SUBJECT: DEMONSTRATION / DELIVERY HOLD - Safety Recall 16S30 - Supplement #4
 Certain 2013-2015 Model Year C-MAX and Escape, 2012-2015 Focus, 2015 MKC
 and Mustang, and 2014-2016 Transit Connect Vehicles
 Side Door Latch Replacement

New! REASON FOR THIS SUPPLEMENT

Technical information updated

- The repair procedures for C-MAX and Focus are updated to eliminate unnecessary steps.

FIGURE 2

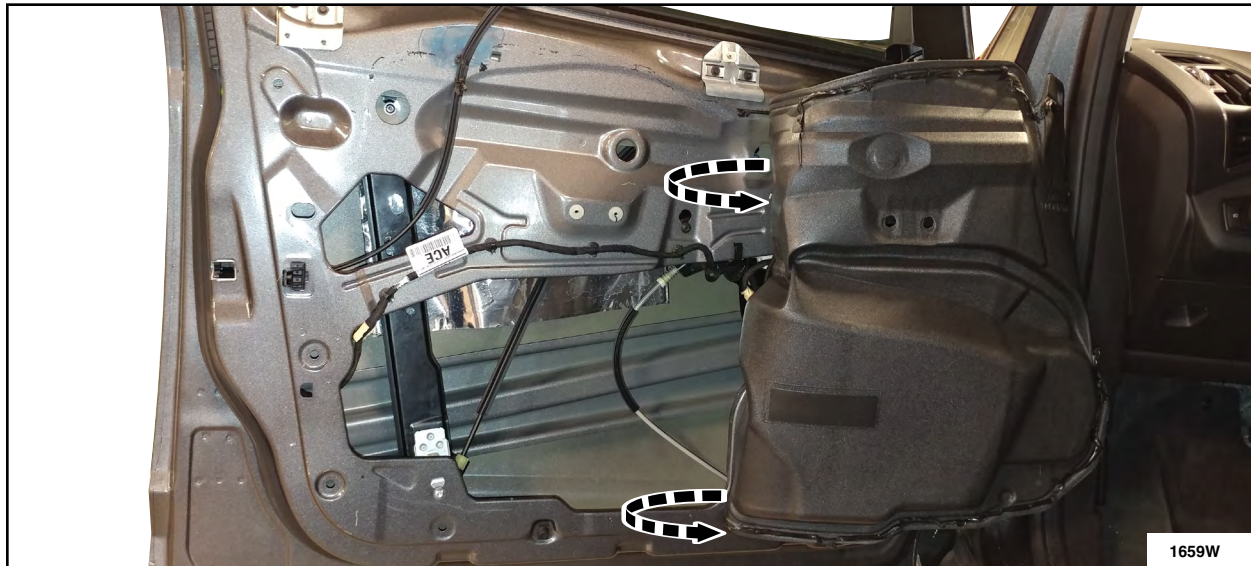
NEW ! C-MAX and Focus Vehicles

NOTE: For front door latch replacement, it is not necessary to remove the door modules, speakers, or water shield. To access components for removal, position aside the water shield as needed. See Figure 2.

1. Replace the front and rear side door latches. Please follow the Workshop Manual (WSM) procedures in Section 501-14.
